UNITED STATES PATENT AND TRADEMARK OFFICE

Office Action Summary	Application No. 10/543,029	Applicant(s) LEGRAND, EMMANUEL	
	Examiner HWEI-SIU C. PAYER	Art Unit 3724

Detailed Action

fig.4

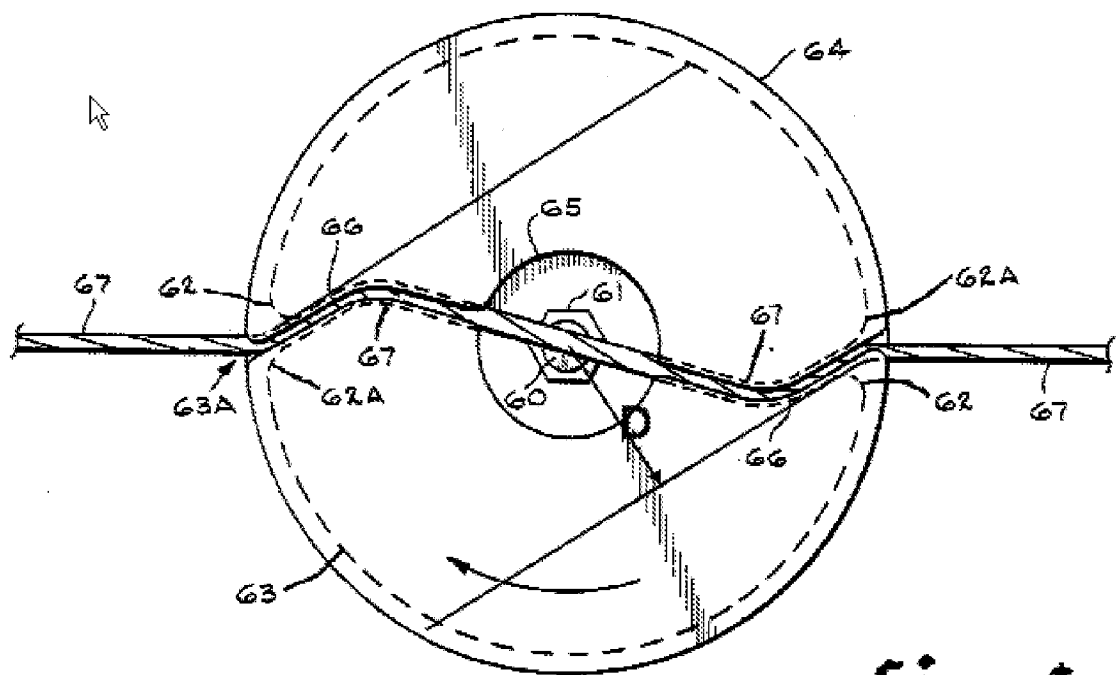
In response to Applicant's argument regarding the Morabit et al. reference, it is noted the reference to be modified is "Ballas et al." not "Morabit et al.". In Ballas et al., the inner edge (i.e. the portion of the passageway 66 within which the cutter string 67 is received) of the passageway (66) engages the trailing edge of the string as claimed.

In response to Applicant's argument with respect to "Moore", it is Ballas et al. that is to be modified not the "Moore" reference. Ballas et al. as modified shows "the passageway extends along an axis that is spaced a distance (D) from an axis of rotation of the head" as claimed. See the following illustration.
